# Land Development and Transportation Committee

## Staff Report

<b>Case No:</b>	13STREETS1008
<b>Request:</b>	Street Name Change for a portion of Notting Hill Boulevard to Ashworth Lane
<b>Project Name:</b>	Notting Hill Boulevard Street Name Change
<b>Location:</b>	308 Notting Hill Blvd.
<b>Owner:</b>	Louisville Metro
<b>Applicant:</b>	Creek Partners, LLC
<b>Representative:</b>	Sabak, Wilson, & Lingo, Inc.
<b>Jurisdiction:</b>	Louisville Metro
<b>Council District:</b>	19 – Jerry Miller
<b>Case Manager:</b>	David B. Wagner – Planner II

3. **Street Name Change Map**

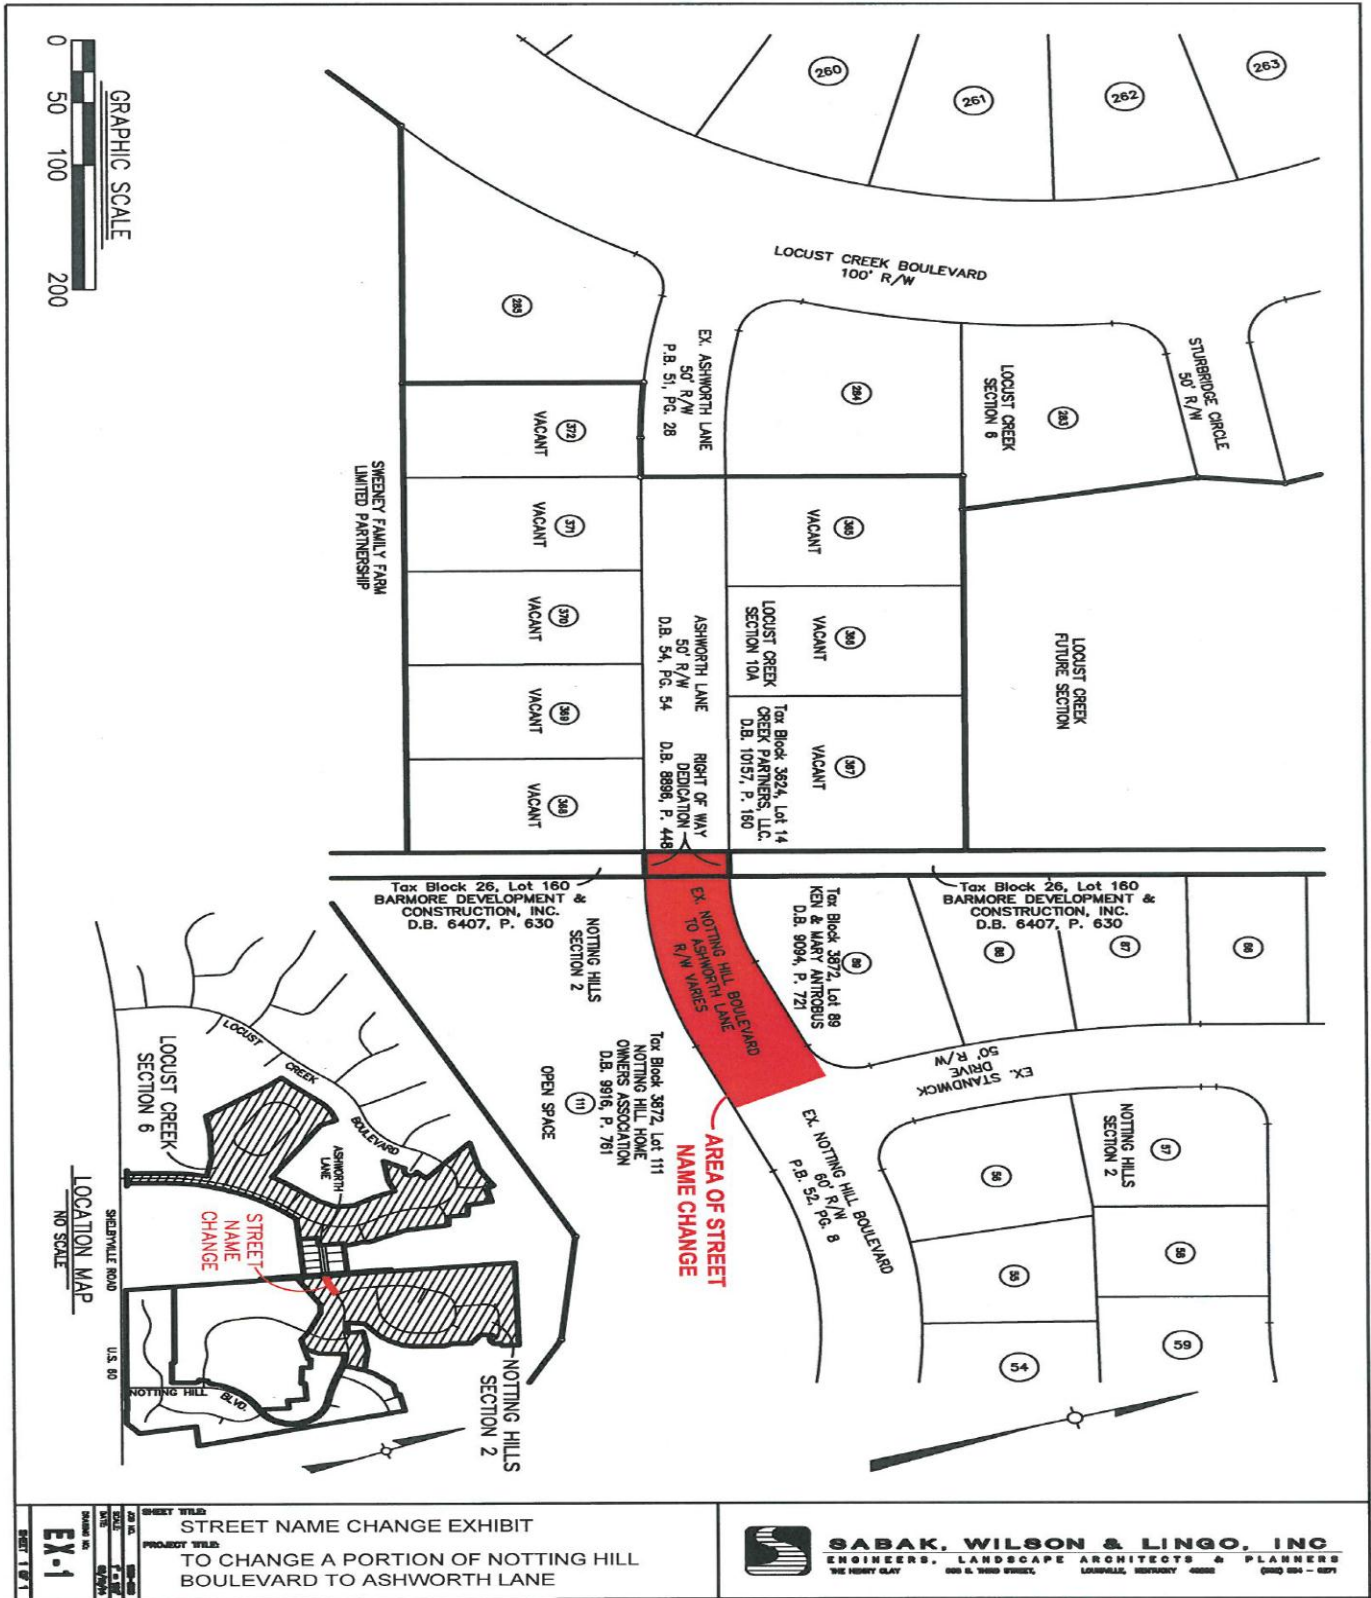
- The request does not conform to LDC Section 6.3.5.K (Continuation of Street names). It states the following: Streets continuing through an intersection shall keep the same name. For commercial, multi-family, or townhouse developments that have an entrance or access through a publicly maintained cul-de-sac, a separate street name will be required for the entrance or access road in the event that it serves or is intended to serve two or more address numbers. Street names shall not be changed due to a change in direction of the street, nor shall a new prefix be used for those streets that meet the criteria for using a directional indicator in the street name.

- MetroSafe is concerned about the request as it would violate the Land Development Code regulation regarding the continuation of street names by not continuing the street name, Notting Hill Boulevard, west of Standwick Drive.

- The Eastwood Fire Department has no concerns with the request.
- If no such request is received, and affected governmental units having geographical jurisdiction agree to the proposed name change, the public hearing maybe waived.
